SUBJECT: EMERGENCY PREPAREDNESS MEETING

This letter and enclosures summarize the March 15, 1996, management meeting held at our request among Mr. M. Slobodien and members of your staff, and members of the NRC Region I staff, in King of Prussia, Pennsylvania. The purpose of the meeting was to discuss the bases for the protective action recommendation (PAR) methodology currently in place for the Three Mile Island and Oyster Creek nuclear power facilities. Enclosed are a copy of the meeting notice, a list of attendees, and a copy of the handout provided by your staff.

Purpose: Management Meeting to discuss the bases for the protective action recommendation logic diagram and methodology for implemetation at Three Mile Island and Oyster Creek.

ENCLOSURE 3
TMI PAR LOGIC DIAGRAM

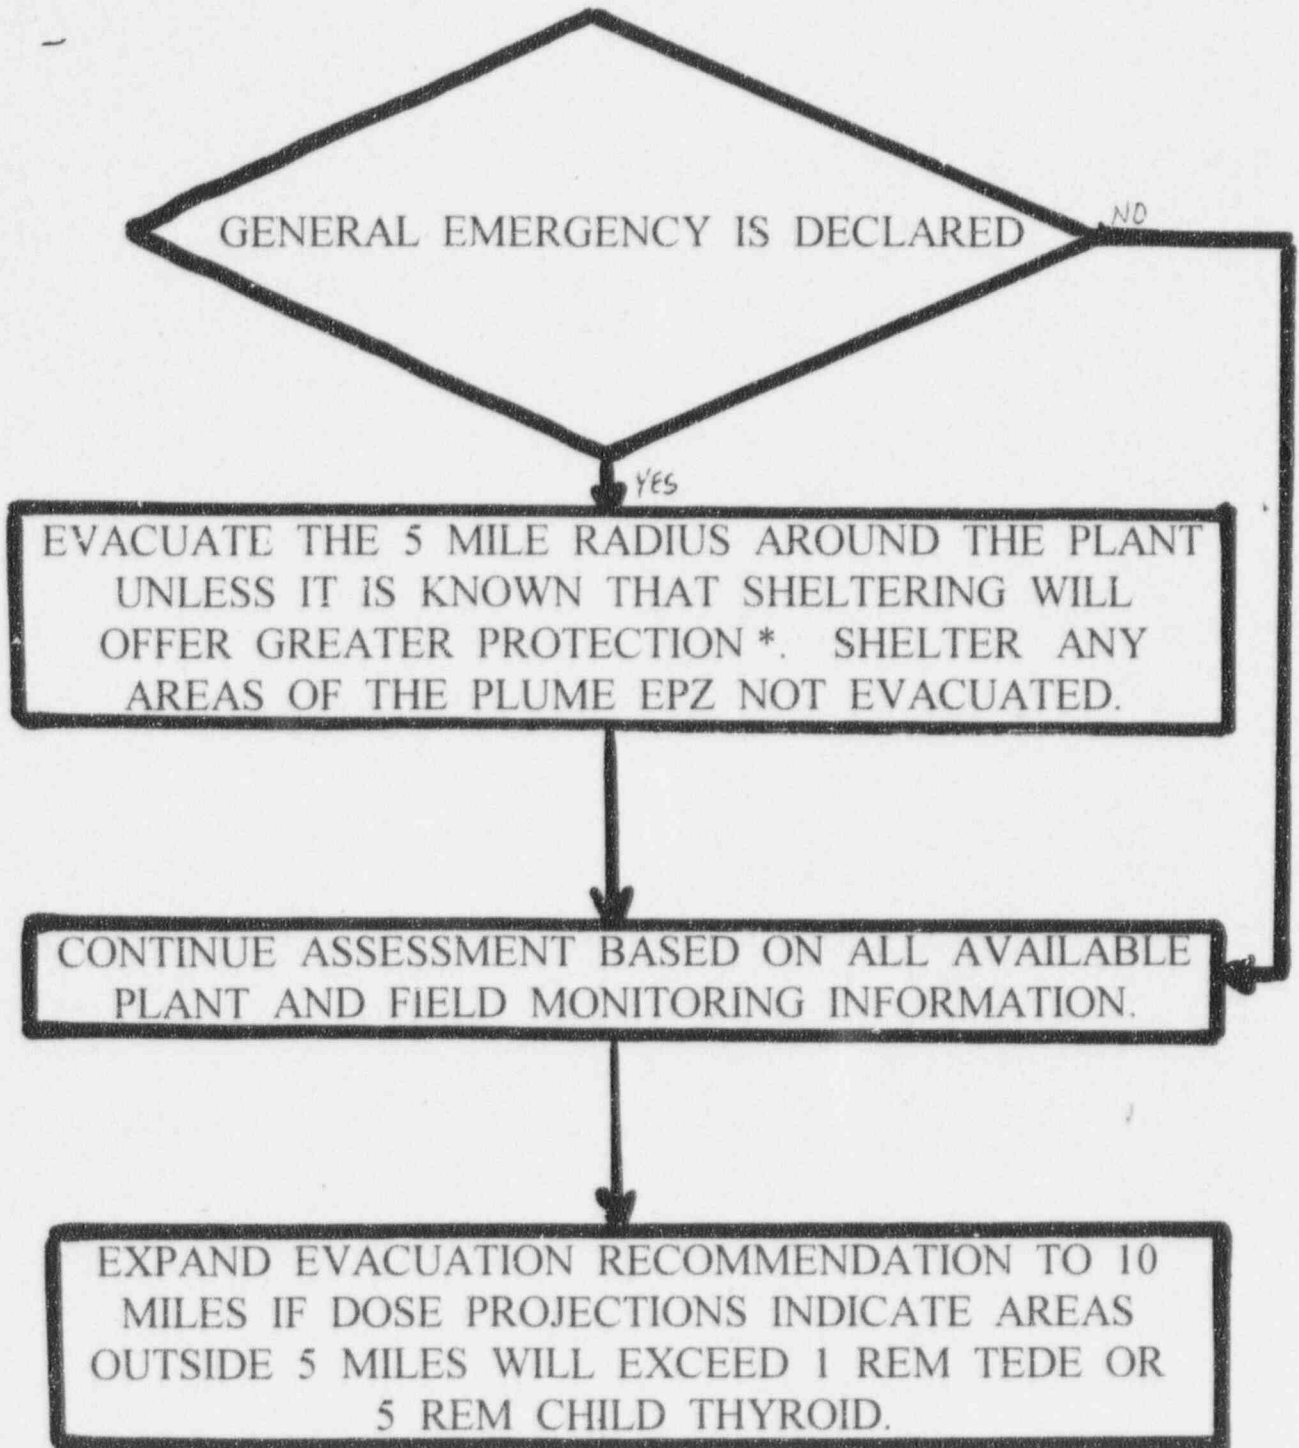
* The decision to recommend sheltering rather than evacuation should be made only when it is clear that sheltering will result in less dose to the public (For example, if it is KNOWN that the release will be terminated within 2 hours of the declaration.)

OYSTER CREEK PAR LOGIC DIAGRAM

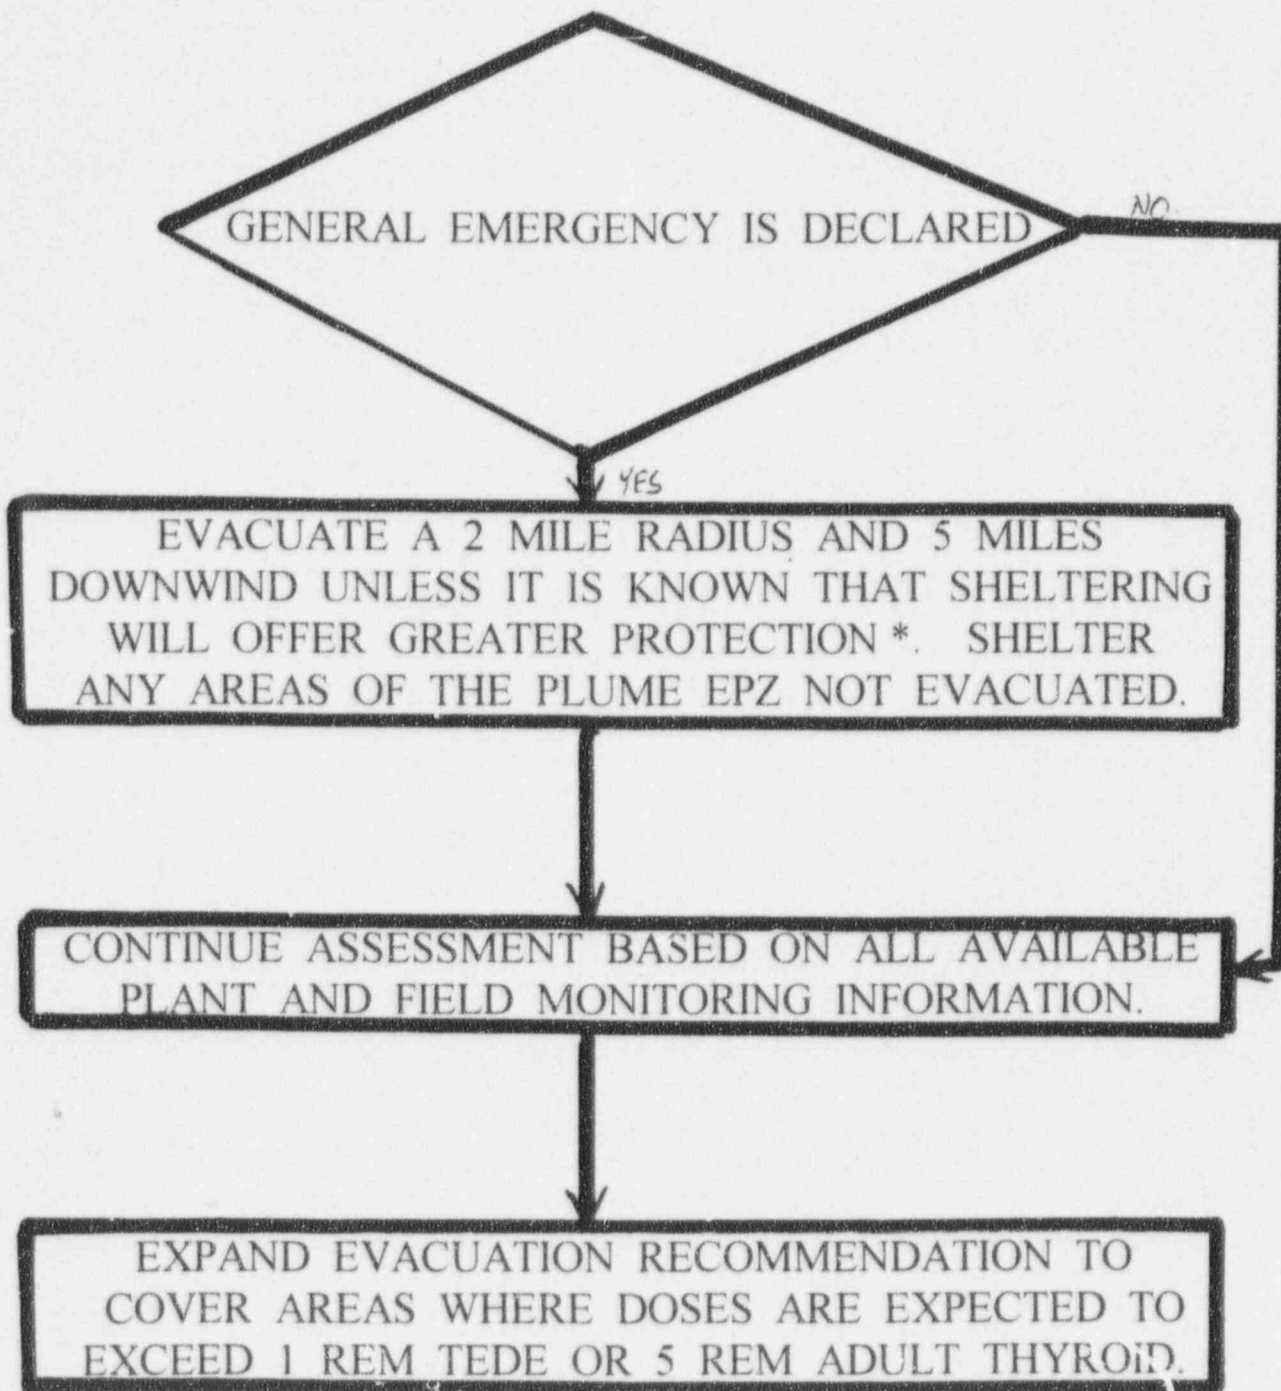
* The decision to recommend sheltering rather than evacuation should be made only when it is clear that sheltering will result in less dose to the public (For example, if it is KNOWN that the release will be terminated within 2 hours of the declaration.)
